ADDENDUM #3

TO: ALL MANDATORY Pre-Bid Meeting Attendees
PROJECT NAME: Contract 76 B.1-Biological Foul Air Mitigation System-Construction-Rebid
BID REFERENCE #: 91359-003.0
BID DUE/OPENING DATE: **April 5, 2022 @ 3:30 p.m. Local Time**

Attachment A

City of Kalamazoo
KWRP Biofiltration
017-7725.001
Pre-Bid RFI

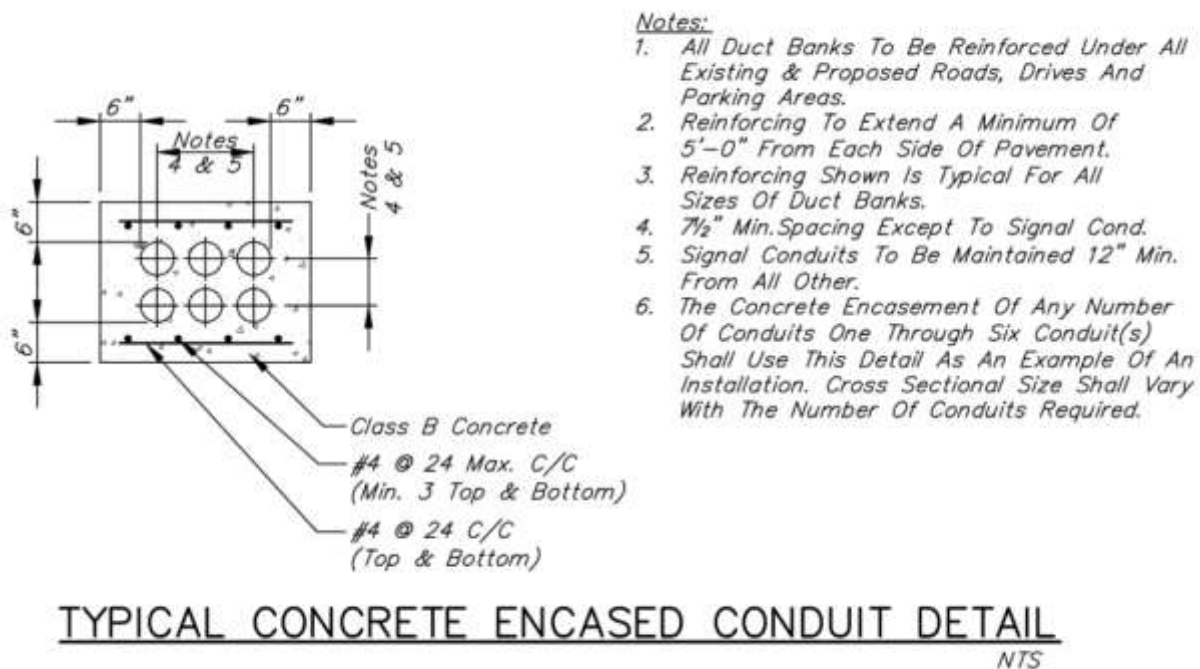
1. There isn't a detail for the duct bank. Can you please provide a detail for the duct bank?
 - See below detail.

2. The electrical duct bank is only shown in the civil drawings (C-5). Are the details in the civil drawings what we are to bid to?
 - See additional details issued with this addendum.

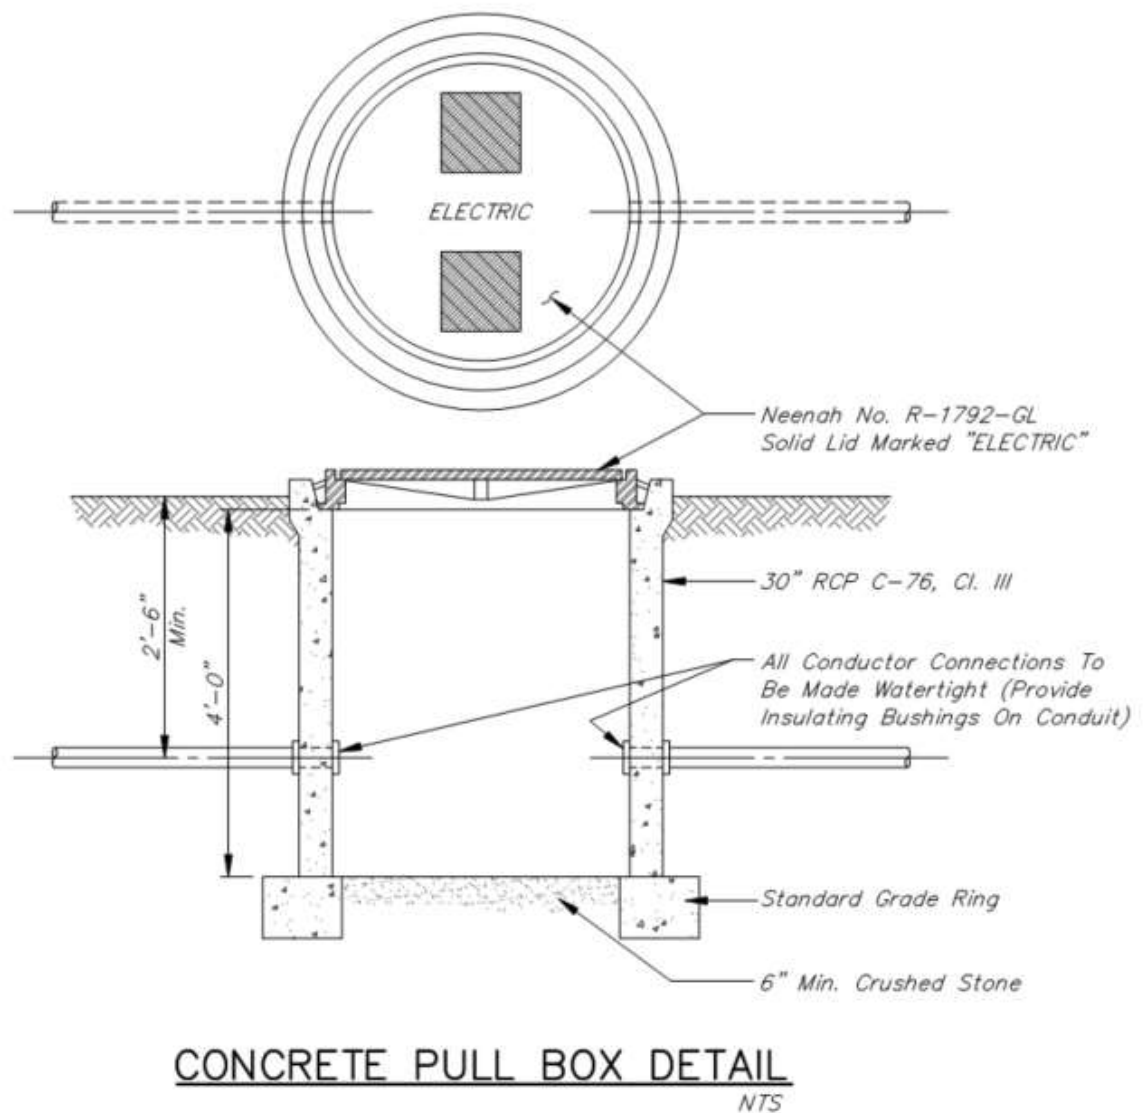
3. On C5 it shows (5) new handhole/manholes. There isn't a detail for us to get pricing for and for labor to install. Can you provide a detail for these please?
 - See below detail.

Note:
Grade Ring Is Required Only When Pull
Box Is Subject To Vehicular Traffic.
